This gallery shows some pictures of bad solderings - they should prevent you from making the same errors (feel free to add even more pictures here!)

<http://wiki.midibox.org/> - **MIDIbox**

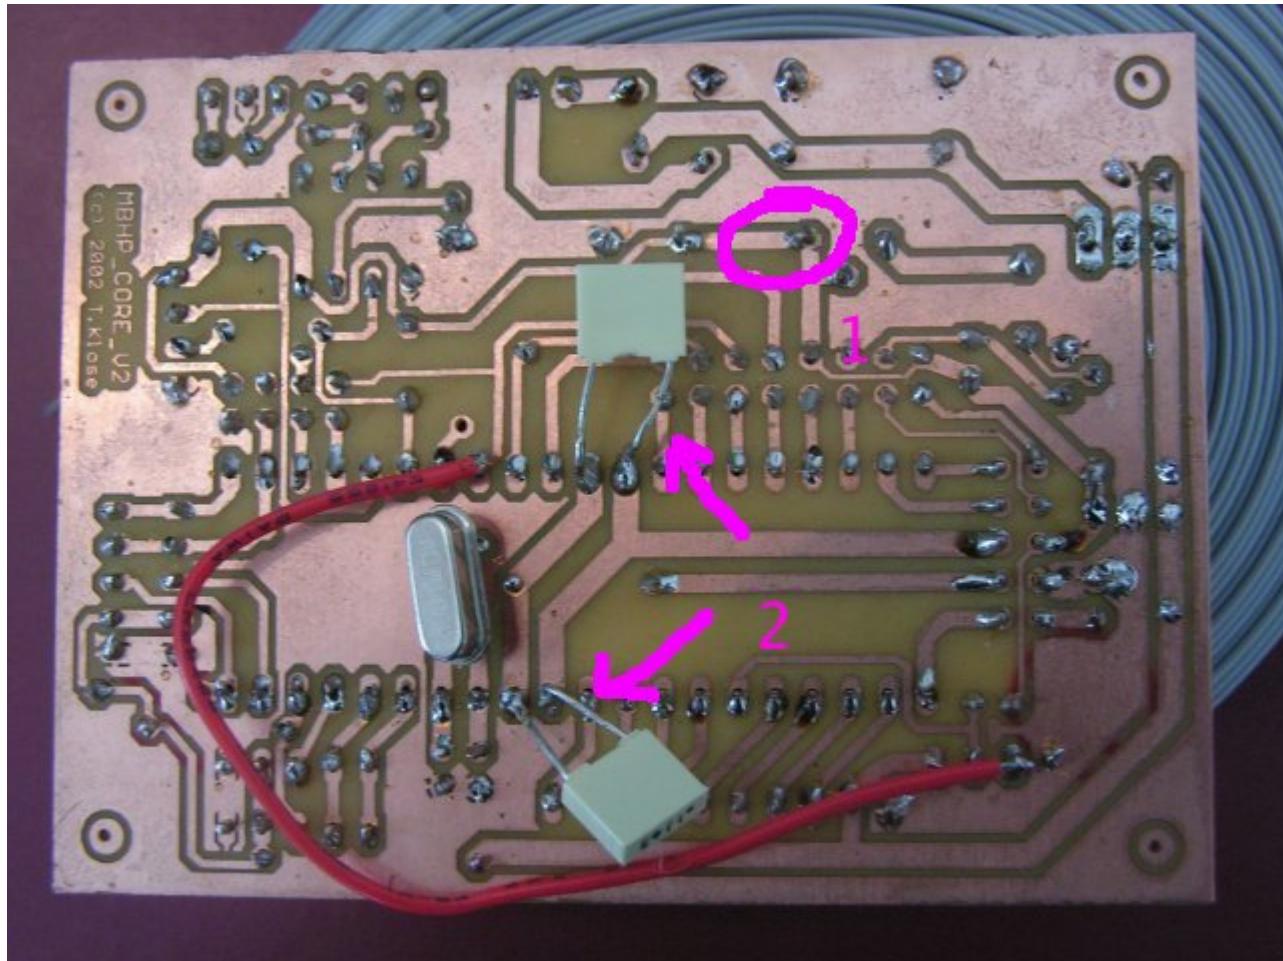
1: the core module has some bad solderings (loose connections), which could lead to failures. There are also missing solderings (e.g. 33pF cap below crystal). It makes sense to solder each pad again, the [Soldering](#) guide in the Wiki gives some useful tips

2: the legs of the caps should be cutted, otherwise they can cause a short circuit which can damage the PIC!

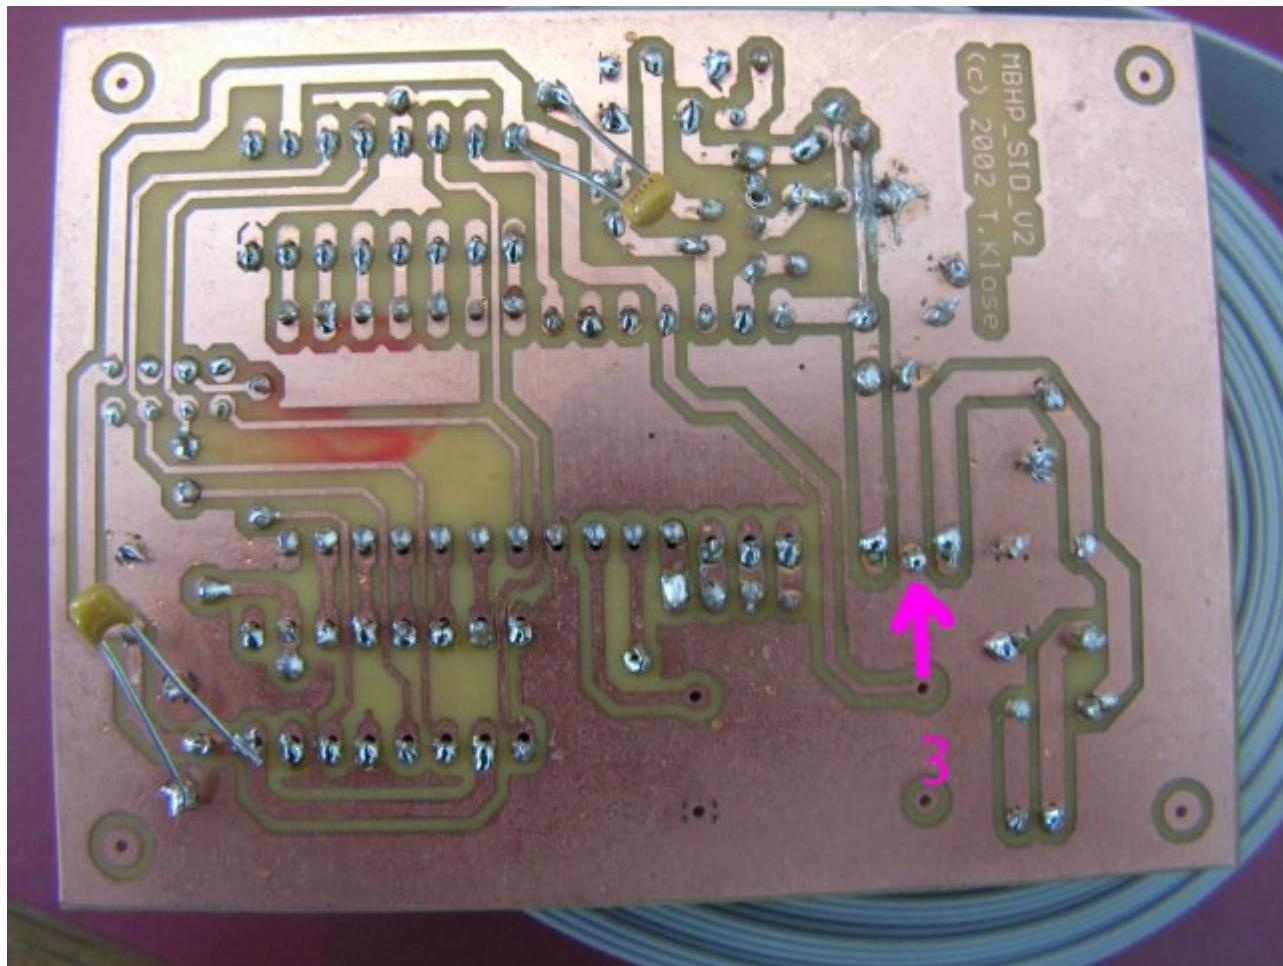
3: this seems to be a bad ground connection directly at the 78xx - it can lead to the wrong voltage. Here the same: just solder the pads again, it will help

And same like above: the long cap legs need to be cutted, the danger for shorts is too high!
